MEMORANDUM

From:	Catherine Brimble Senior Landscape Officer		
Service	WBC Landscape and Trees	App No:	252255
Address:	Unit 1, 171 Evendons Lane, Wokingham, RG41 4EH.		
Proposal:	Application for submission of details to comply with the following condition of planning approval 231351 dated 12.11.2024. Condition 3 relates to materials, 4 to ground and building levels, 6 to construction management, 9 to landscape details (large scale), 11 to protection of existing trees, 12 to landscape management plan, 13 to earth mounding and contouring, 14 to hedgerows, 15 to contamination, 17 to cycle parking, 18 to details of car and motorcycle parking, 20 to vehicle turning, 21 to construction access, 22 to access, 25 to travel plan, 26 to walking and cycling strategy, 27 to LEMP, 28 to ecological permeability, 29 to details of boundary walls and fences, 30 to noise impact assessment, 31 to odour extraction details, 32 to drainage, 35 to BREEAM compliance, 37 to communications plan, 42 to bat Licence.

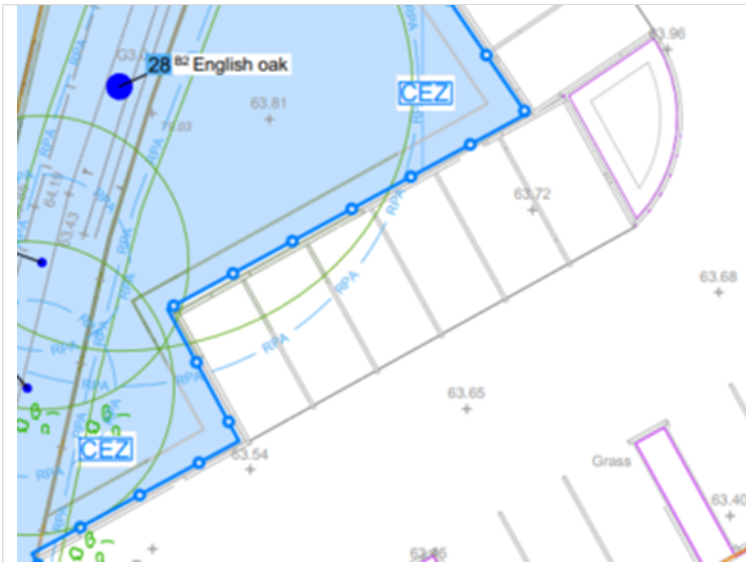
The parking bays within the RPA of #28 a category B Oak, but outside the location of the tree protection fencing, will need to be identified as being no-dig on the TPP, i.e. constructed above the existing ground levels (see area in question below). The Proposed Levels drawing indicates existing ground levels will be reduced in this area to form the finished surfacing level, and this doesn't account for the further excavation required for constriction of the parking bays (approximately 430mm based on construction details). A 600mm reduction in ground levels in the RPA of the retained tree is not acceptable and a design solution will need to be found to ensure a no-dig solution can be implemented in this location instead.
